SHDC
PLANNING & DEVELOPMENT
~ 5 SEP 2006
Ref. 1246106

CORSAIR

DETERMINED
PLAN

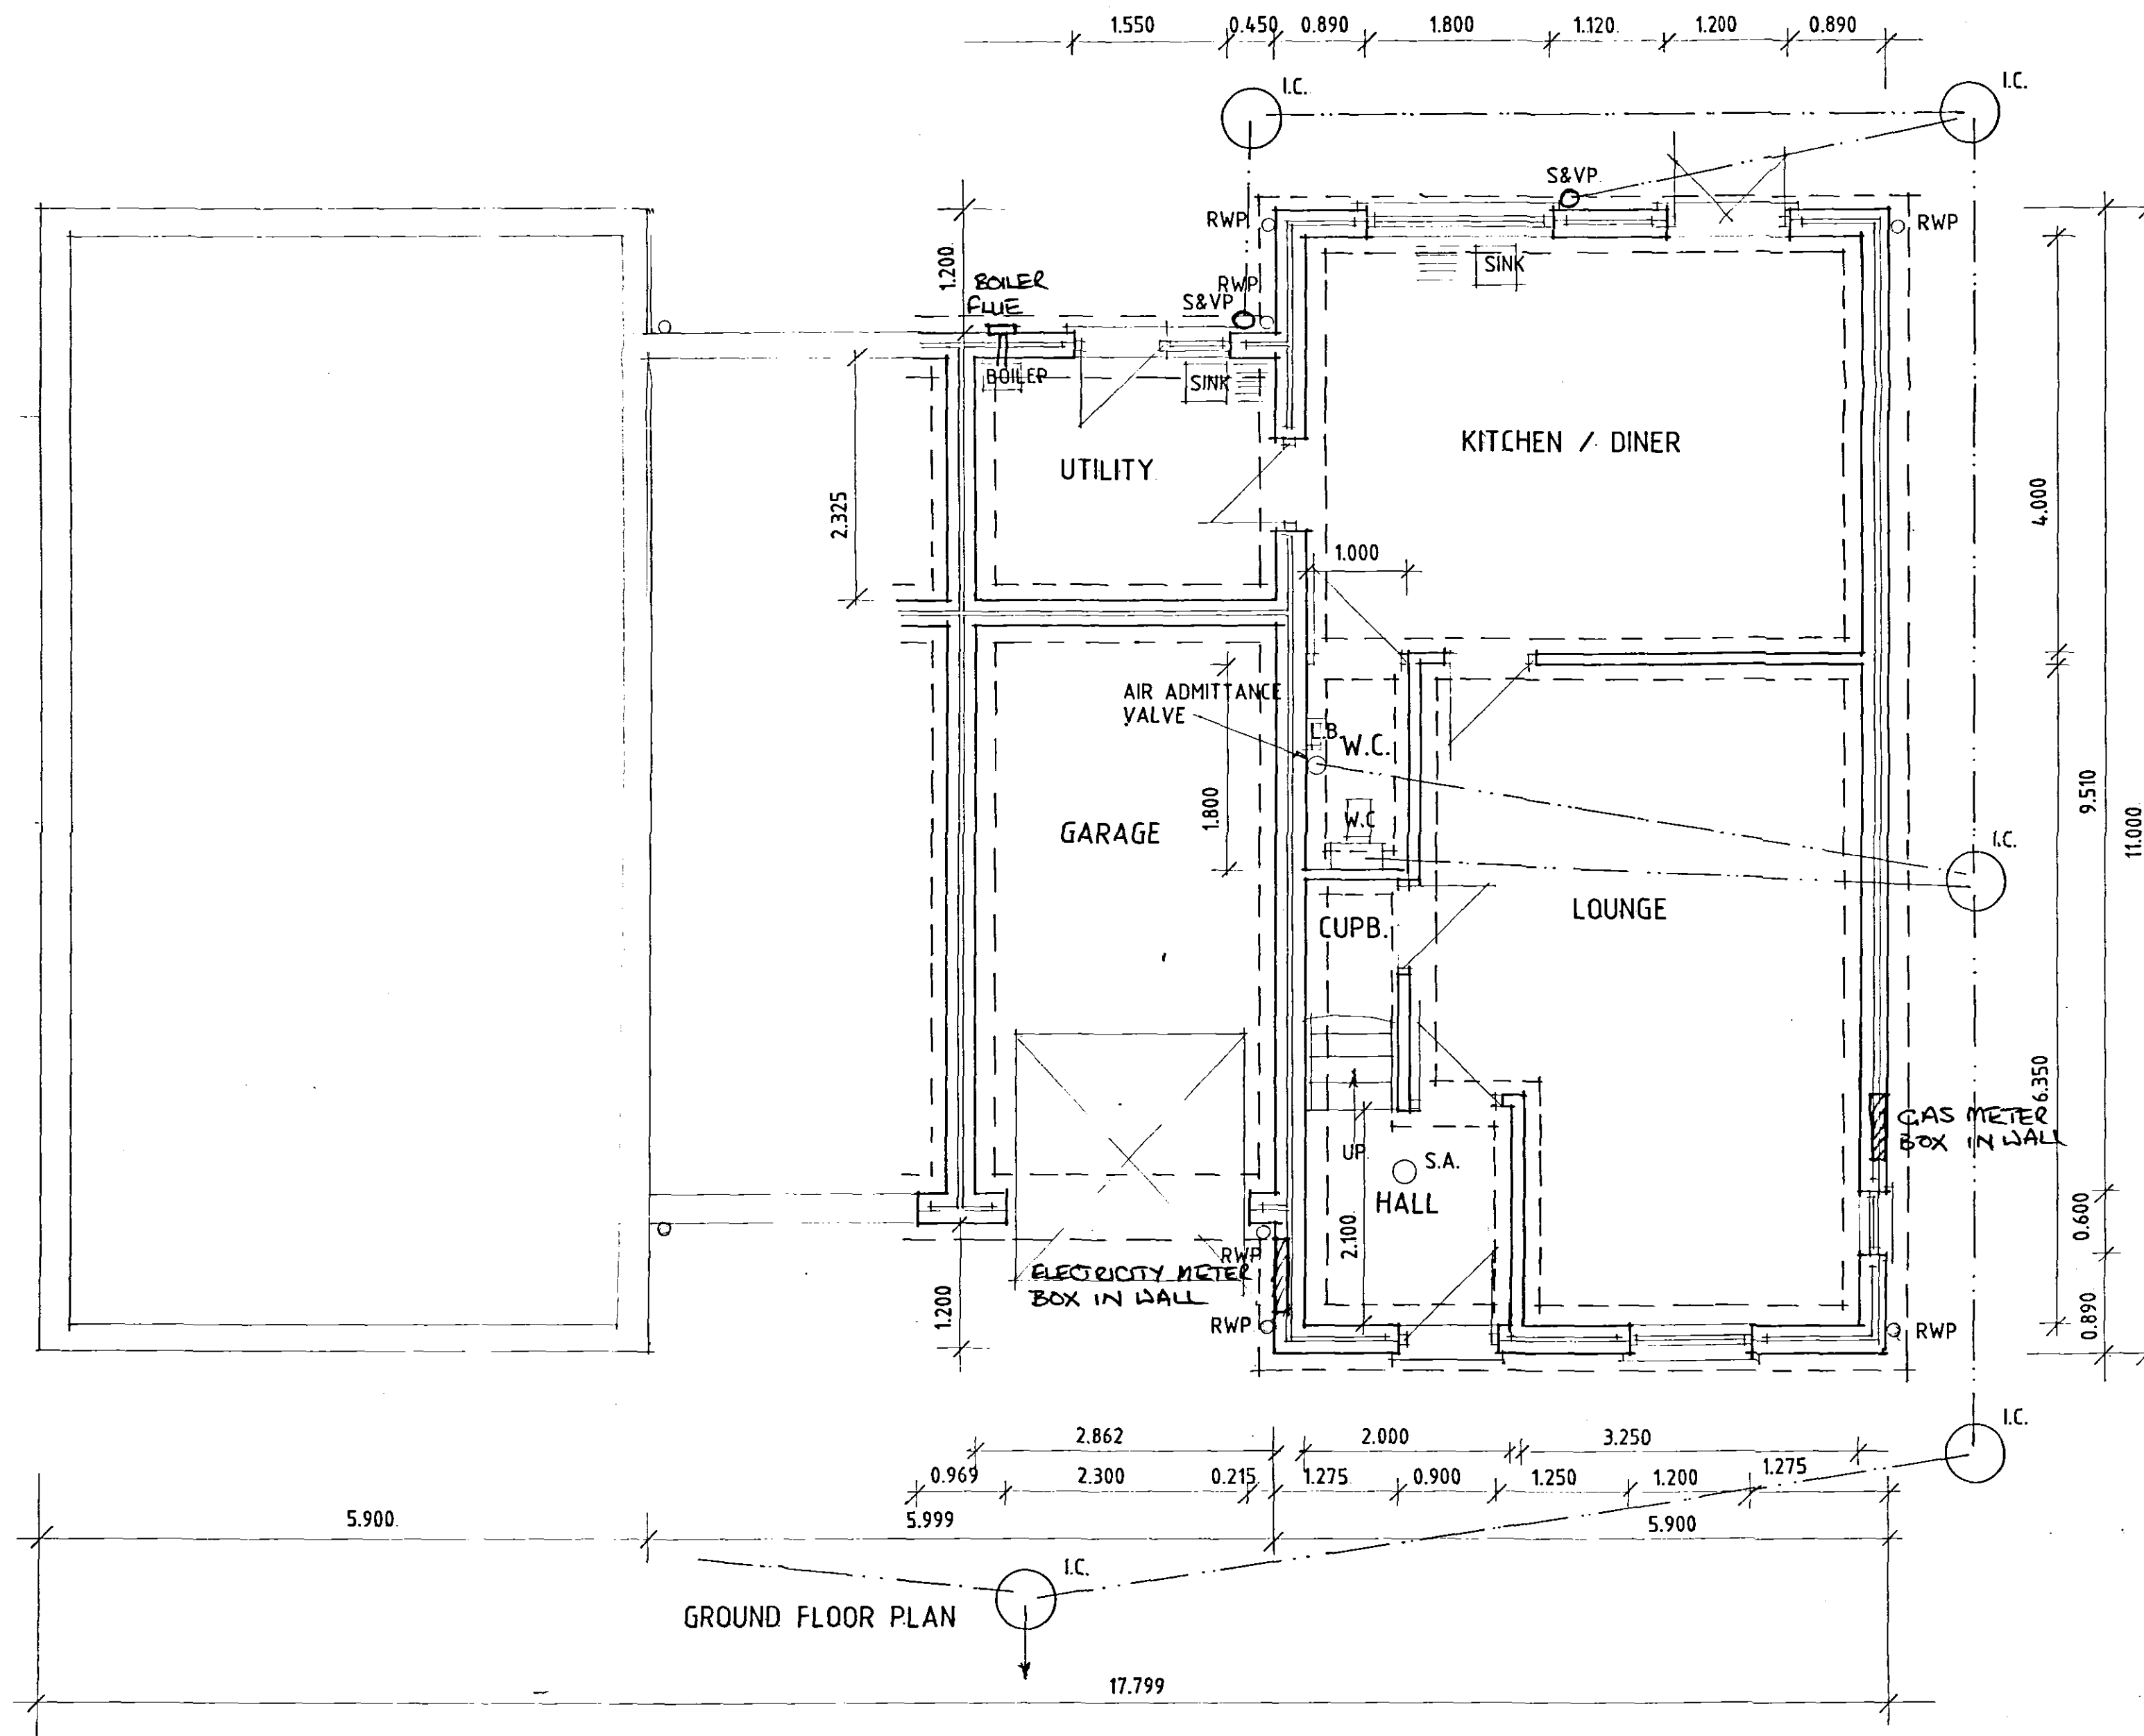
All windows in Lounge to be fully openable.
To party wall, wall ties to be Type A not butterfly type.

Ensure roof lights to Bedroom 3 have opening casement within 1.1m of floor as means of escape.
